LIME DOWN SOLAR PROJECT

DEADLINE 5 SUBMISSIONS STOP LIME DOWN

August 2026

Figure 8. Watercourses impacted by runoff from each area of Lime Down

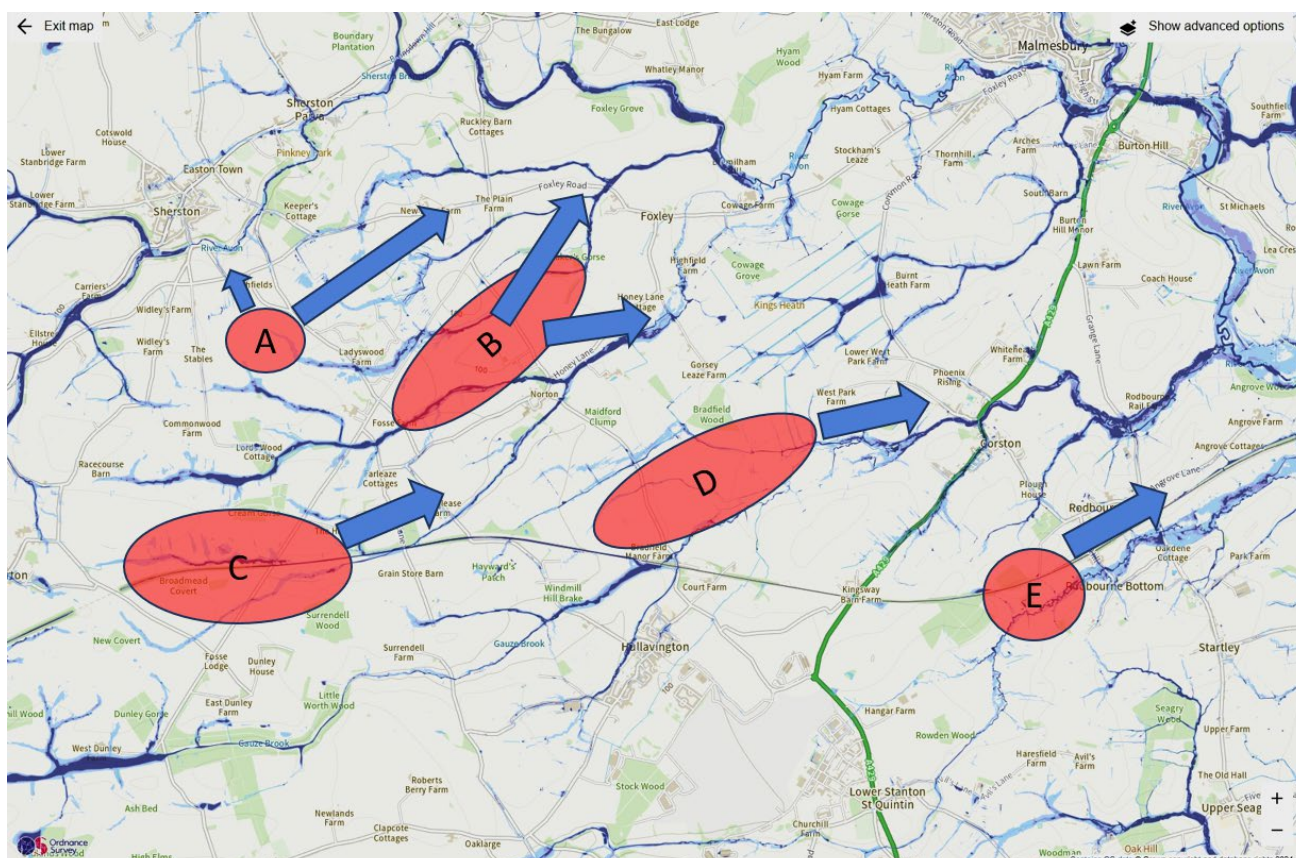
40. The results can be used to assess the watercourses most at risk for off-site flooding. The Applicant has provided flowpaths on drainage maps in Figures 11-1- to 11-7, Rev 2, [REP3-

027] to [REP3-033] which show nothing very unexpected though it is not clear how they have been calculated. On this basis the watercourses impacted by each part of the Scheme can be summarized schematically as in Fig. 8. Area A drains principally into the “unnamed watercourse” which reaches the Avon just downstream of Whatley Manor. Area B has reduced in size since the map was prepared, and the flow is also now principally into this stream. Area C drains into the Norton Brook which reaches the Avon at Cowage Farm. Area A also makes a small contribution to the Norton Brook, and the drainage from Area C is enhanced by runoff along the railway culvert and from flood-prone areas near Farleaze Farm. Area D drains exclusively into the Gauze Brook and Area E into the Rodbourne Brook. The PV-SMaRT analysis shows that the areas most at risk of generating runoff are Areas A, C and E. Runoff into the Norton Brook puts houses in Foxley at risk. To a lesser extent, houses in Malmesbury are put at risk by enhanced runoff into the Avon from the Norton Brook and “unnamed watercourse”. The Applicant has provided no assessment of these risks. The PV-SMaRT analysis suggests that Corston and the Gauze Brook will be less affected by panel runoff. The Rodbourne Brook will be affected, and Bottom Farm and its fields and buildings in Rodbourne Bottom are potentially affected. Again, the Applicant has provided no assessment of such off-site risks because of their assumption that solar panels will not affect runoff. All these waters discharge into the Bristol Avon, with potential effects downstream at Chippenham, Melksham and Bradford-on-Avon.
